United States Patent and Trademark Office

| PPLICATION NO. | 1 | FILING DATE | FIRST NAMED INVENTOR | ATTORNEY DOCKET NO. | CONFIRMATION NO |
|----------------|--------------------------|------------------|----------------------|-------------------------|-----------------|
| 10/809,203 | 03/25/2004 | | Toshimitsu Hirai | 9319S-000716 | 5989 |

| | | Application No. | Applicant(s) | | | | |
|---|---|---|---|--|--|--|--|
| Office Action Summary | | Examiner | Art Unit | | | | |

DETAILED ACTION

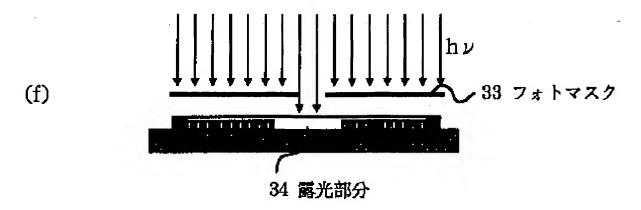
Kamishiro discloses removing banks (Drawing 2(a), Resin constituent layer 32) after the conductive layer (Drawing 2 (d), Metal constituent for electrodes 35) and element electrode are formed as seen in Drawing 3(g)-3(i)

Kamishiro discloses a step of removing banks in Drawing 3(f) - 3(i) below

after forming electrode(37), the bank region has been removed.

Therefore, the rejection of claims 1 and 9 under 35 U.S.C. 102(b) is deemed proper.
